ADDENDUM No. 1
for
INDIANA STATE FAIR COMMISSION
DISCOVERY HALL TENANT
IMPROVEMENTS
1202 East 38th Street
Indianapolis, Indiana 46205

July 8, 2011

ADDENDUM NO. 1

PARTIAL FIRST FLOOR MECHANICAL PLAN

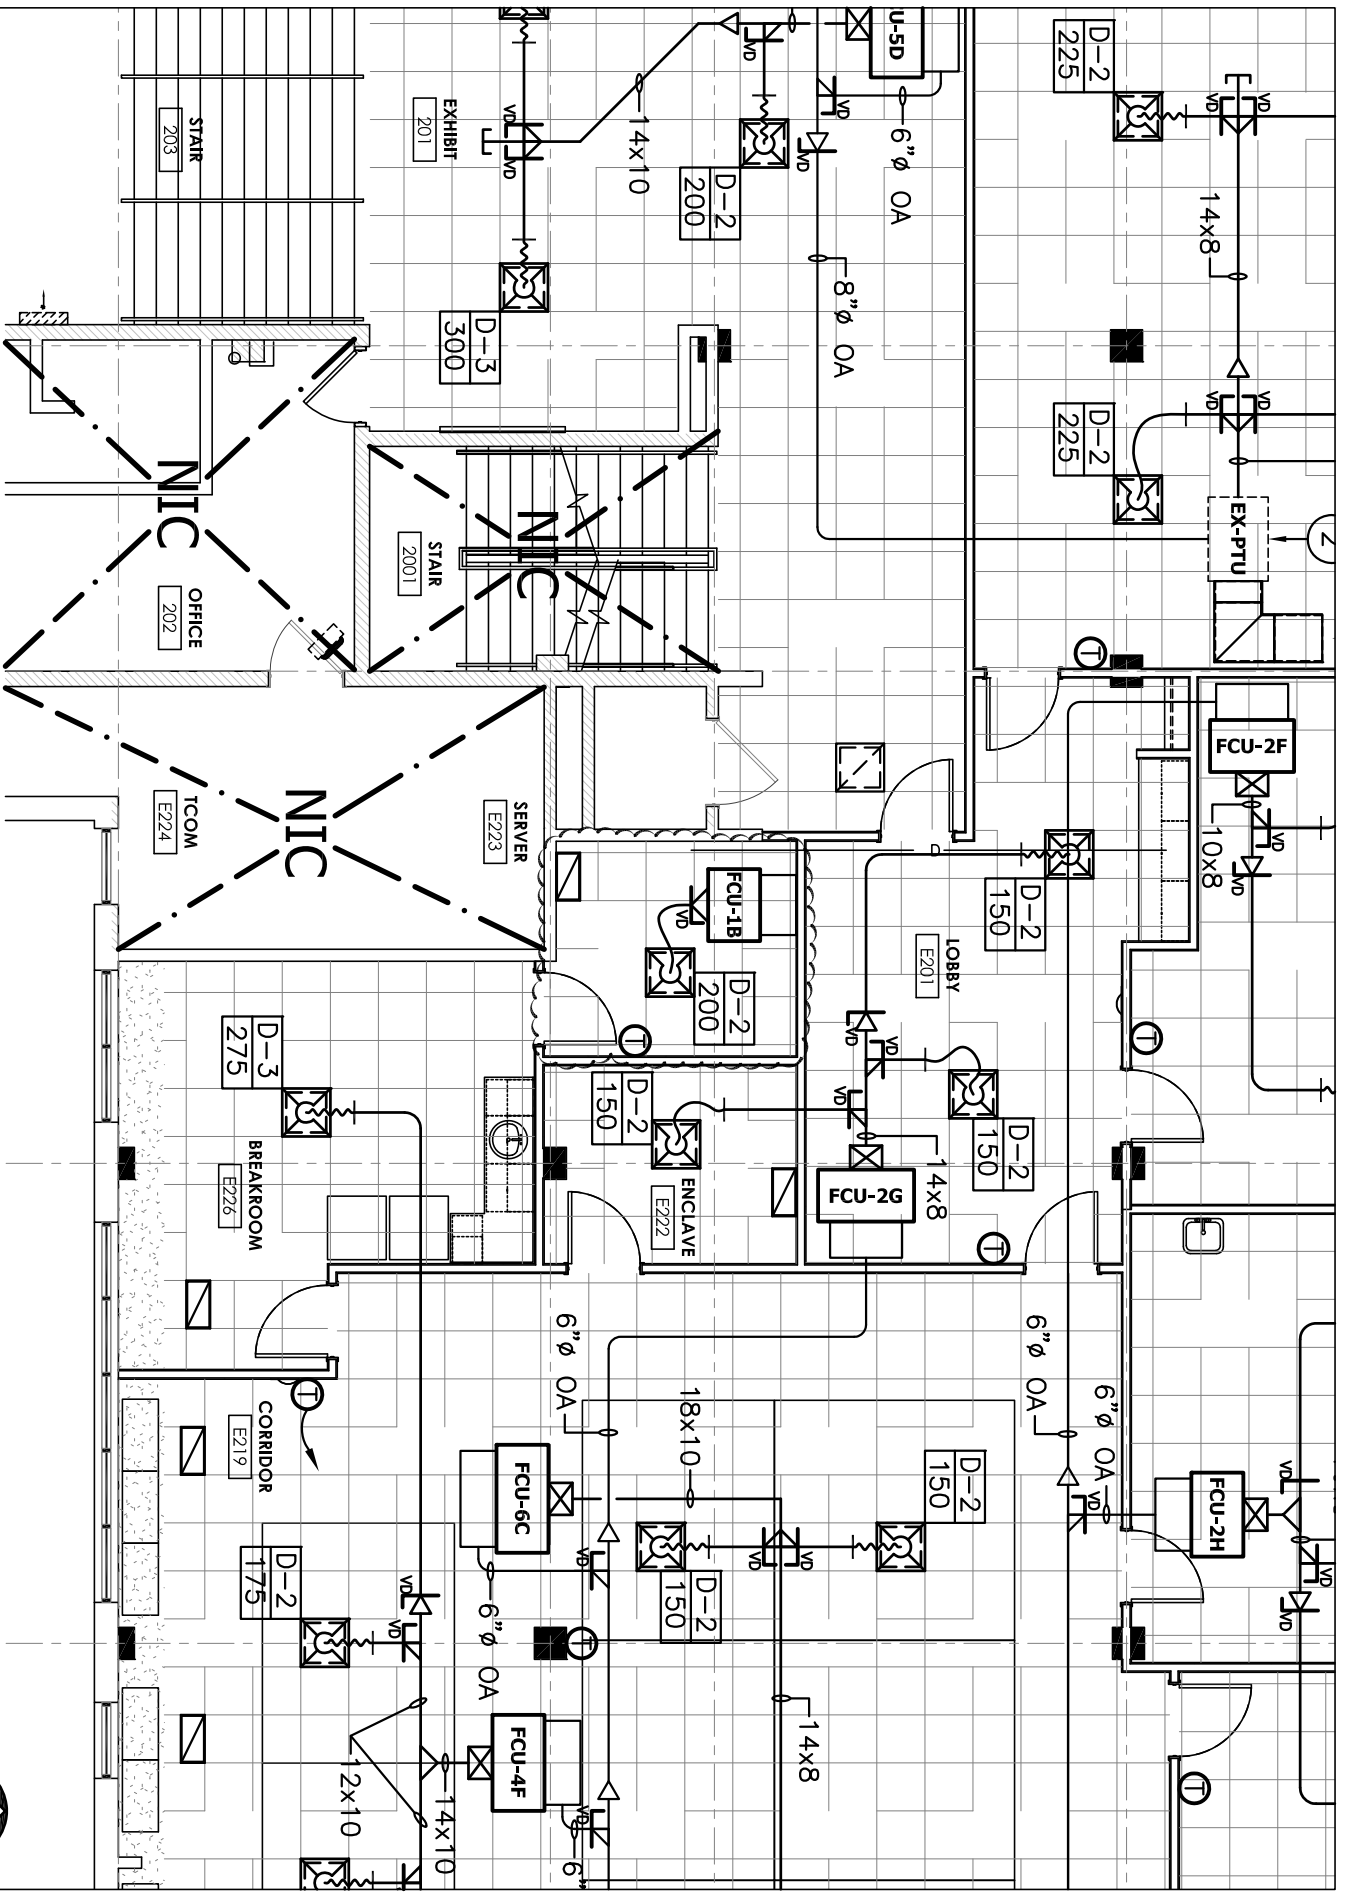
1. Add diffuser, thermostat, ductwork, volume damper, and fan coil unit FCU-1A to IT Room B103. See attached partial plan M101a.
2. From Plan Note 4, delete "x (length as shown)" and add to Plan Note 4 "All transfer air ducts will be made with fiberglass lined duct and shall include at least two 90 degree elbows.

1. Add diffuser, thermostat, ductwork, volume damper, and fan coil unit FCU-1B to Server Room E223. See attached partial plan M102a.
2. From Plan Note 4, delete "x (length as shown)" and add to Plan Note 4 "All transfer air ducts will be made with fiberglass lined duct and shall include at least two 90 degree elbows.

PARTIAL FIRST FLOOR MECHANICAL PIPING PLAN

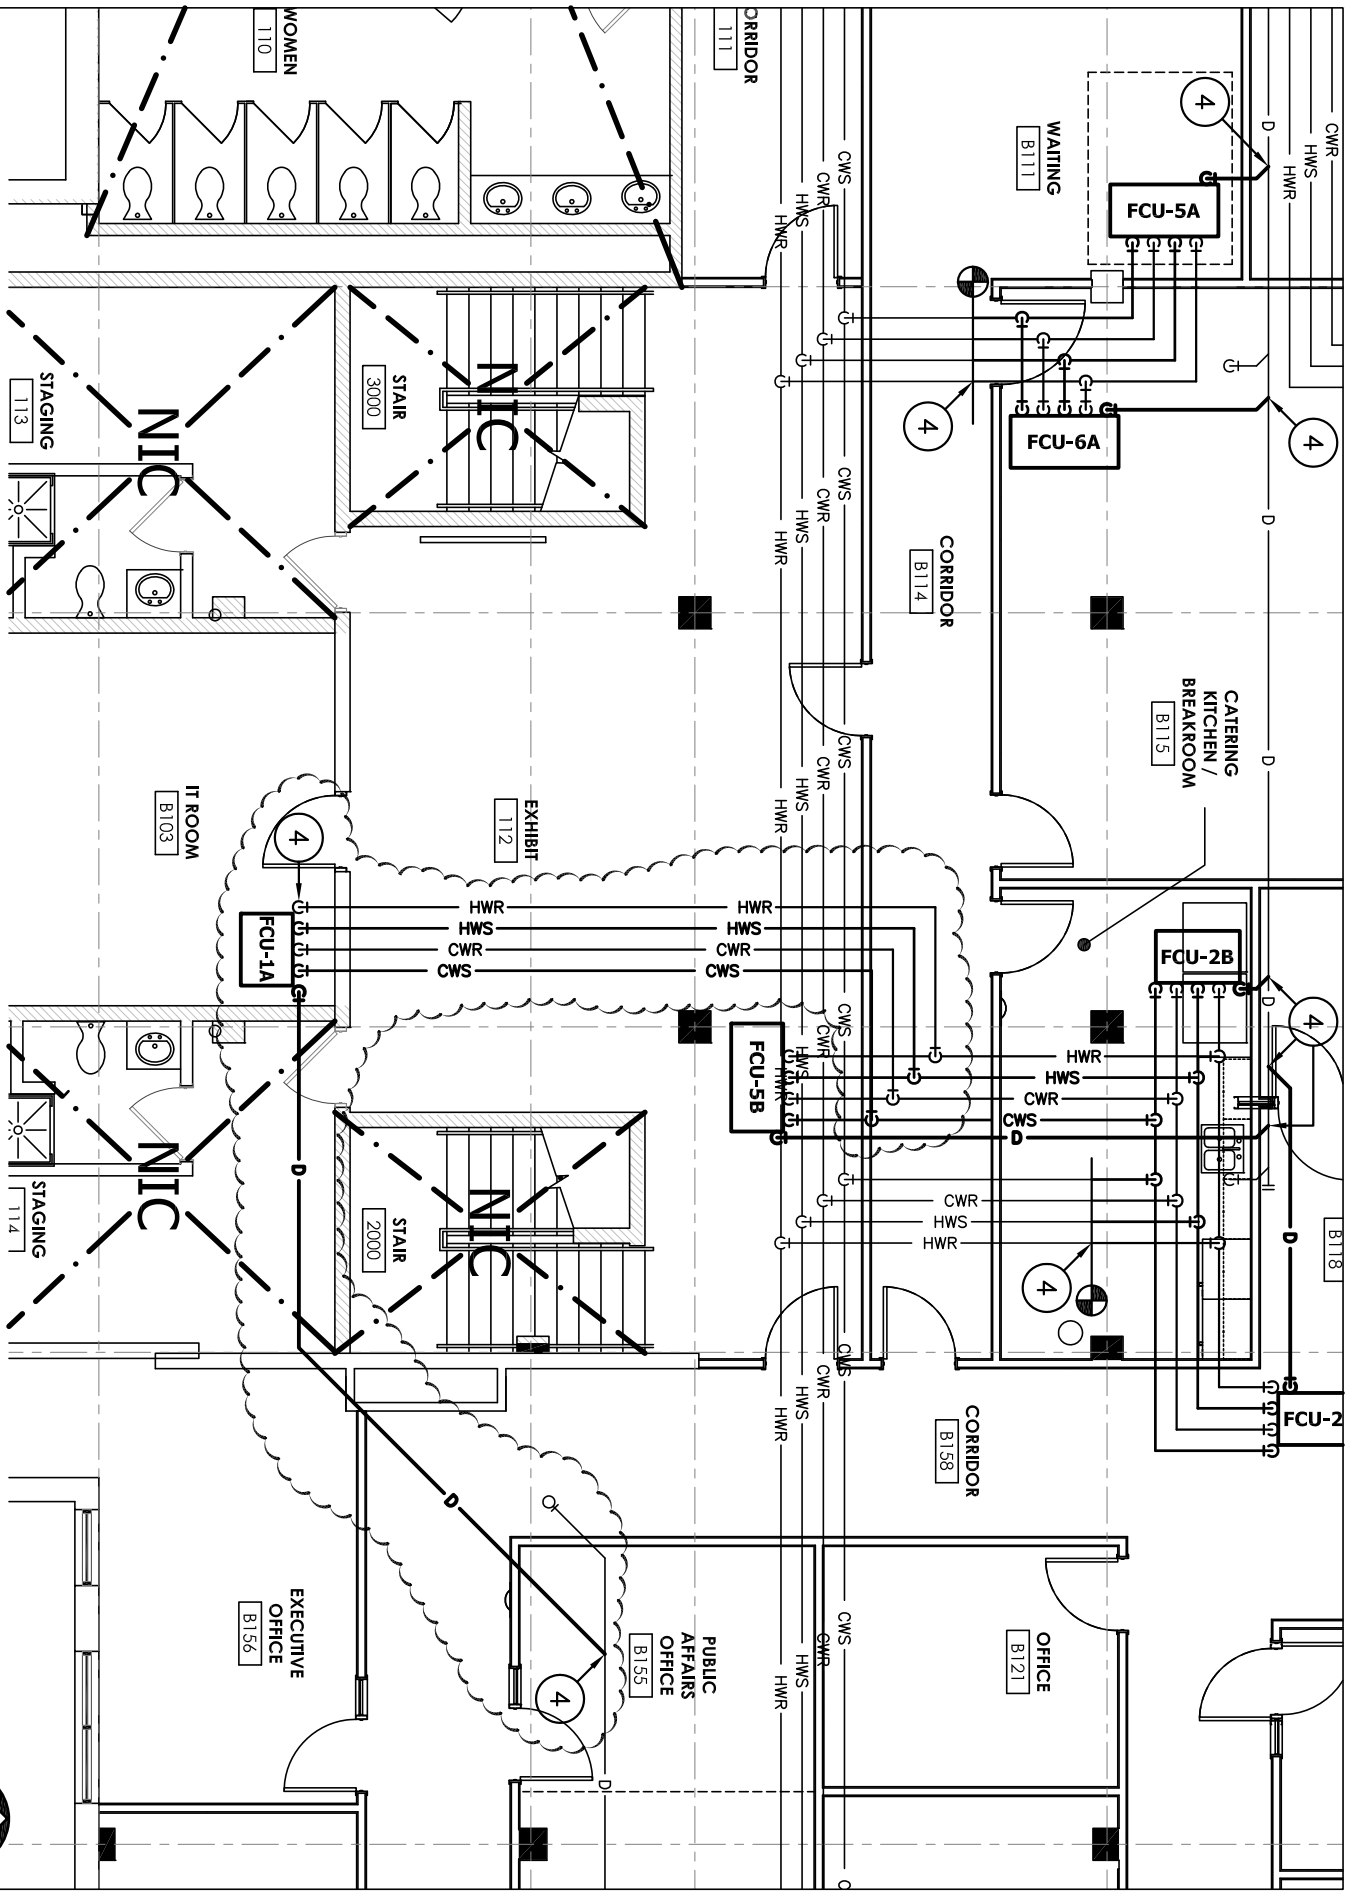
1. Provide hot and chilled water piping to the new fan coil unit FCU-1A. See attached partial plan M103a.

PARTIAL SECOND FLOOR MECHANICAL PIPING PLAN

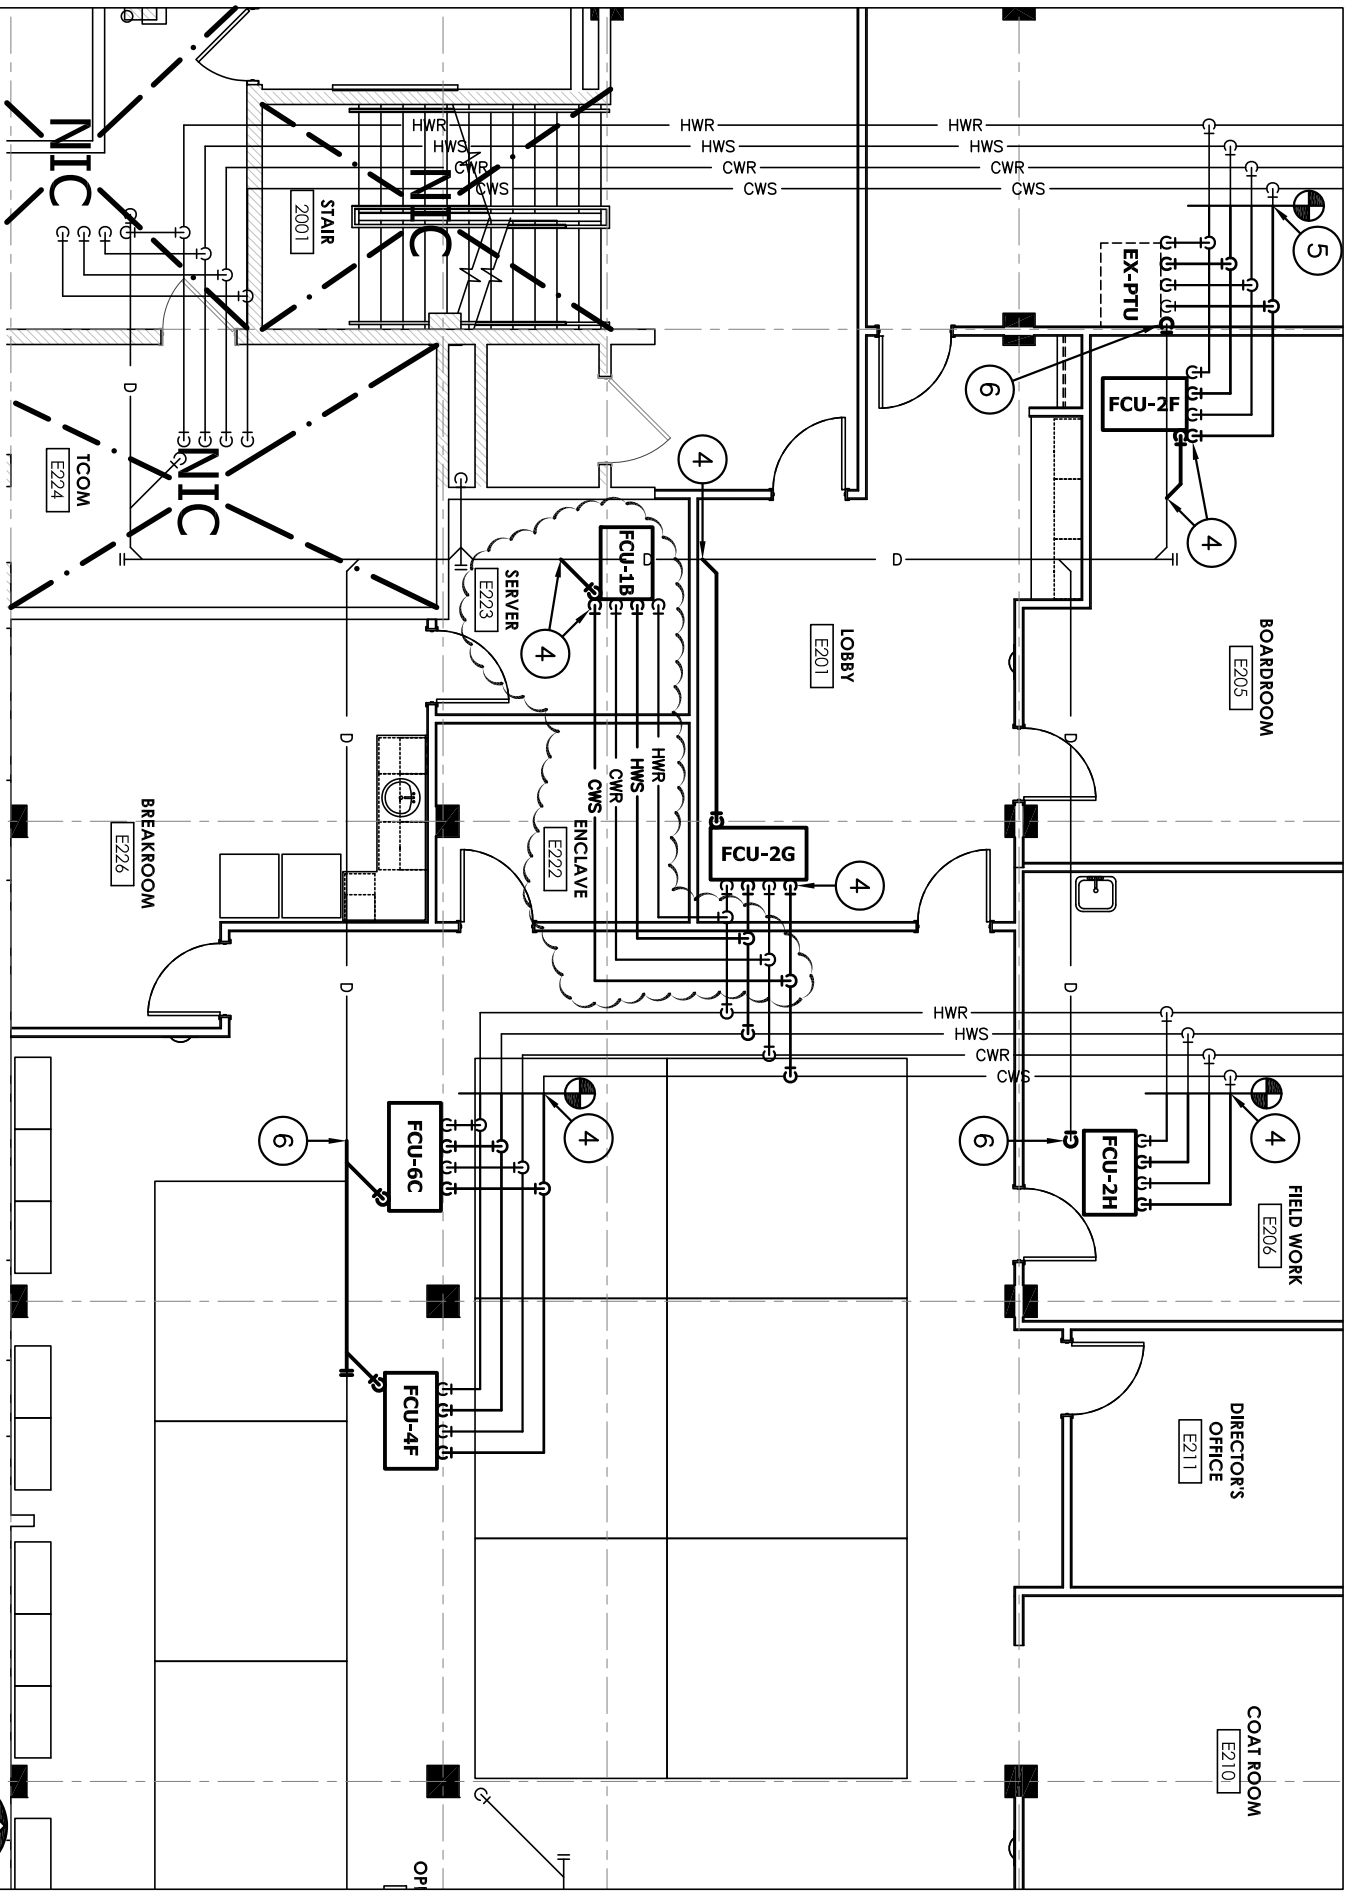
1. Provide hot and chilled water piping to the new fan coil unit FCU-1B. See attached partial plan M104a.
